RE: Concerns Regarding the U.S. Department of Energy's Recent Actions During the U.S. Environmental Protection Agency's Review of the December 31, 2020 Radionuclide Pollution Decision for the Oak Ridge Reservation Facility in Oak Ridge, Tennessee

Re: Concerns with DOE Actions Taken in Reliance on the Radionuclide Pollution Decision August 2, 2021
Page 2 of 10

Figure 1. Site Characterization: Groundwater Levels. 17

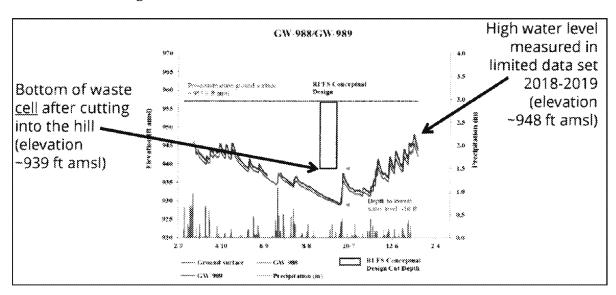
New groundwater information significantly changes the features of the remedy the Department has proposed: to construct a landfill that would taint a greenfield on the Oak Ridge Reservation (the Proposed Plan). ¹¹ In the Proposed Plan, the Department claimed the location was the "most appropriate area on the [Oak Ridge Reservation] for locating an onsite disposal facility" in part due to its "groundwater flow conditions," citing the "considerable amount of information" available about the subsurface and groundwater conditions in Bear Creek Valley. ¹² At the time of the public comment period, the Department told the public that the landfill would maintain a "10 ft geologic buffer above seasonal high groundwater." ¹³ The Department said that "[r]esults of the Phase 1 site characterization confirm the acceptability of the [landfill] site for a new, low-level waste landfill and support final site selection." ¹⁴ However, recently released Technical Memorandum 2 reveals that groundwater levels at the site are significantly higher than originally anticipated and understood. ¹⁵ According to the new groundwater information, a substantial portion of the landfill would sit below the water table. ¹⁶ (Figure 1).

The newly revealed groundwater levels at Bear Creek Valley raise critical questions about the design and performance of the landfill as proposed. The U.S. Environmental Protection Agency's (EPA) comments on Technical Memorandum 2 underline that the proposed landfill must have "a completely unsaturated clay geobuffer layer to demonstrate the protectiveness requirements necessary to obtain waivers." However, the landfill as proposed would sit below the water table, and there is a substantial risk that waste would not be adequately contained. The Tennessee Department of Environment (TDEC) stated that Technical Memorandum 2 "raises significant questions about how [the Department] will support the contention that the [proposed landfill] site is acceptable." More explicitly, TDEC stated that Technical Memorandum 2 "makes it difficult to determine if the landfill can be constructed and operated in a manner that will meet the two CERCLA threshold criteria." In the wake of this new information, the Department has not altered the Proposed Plan or given the public an opportunity to comment on the issues raised by this new information.
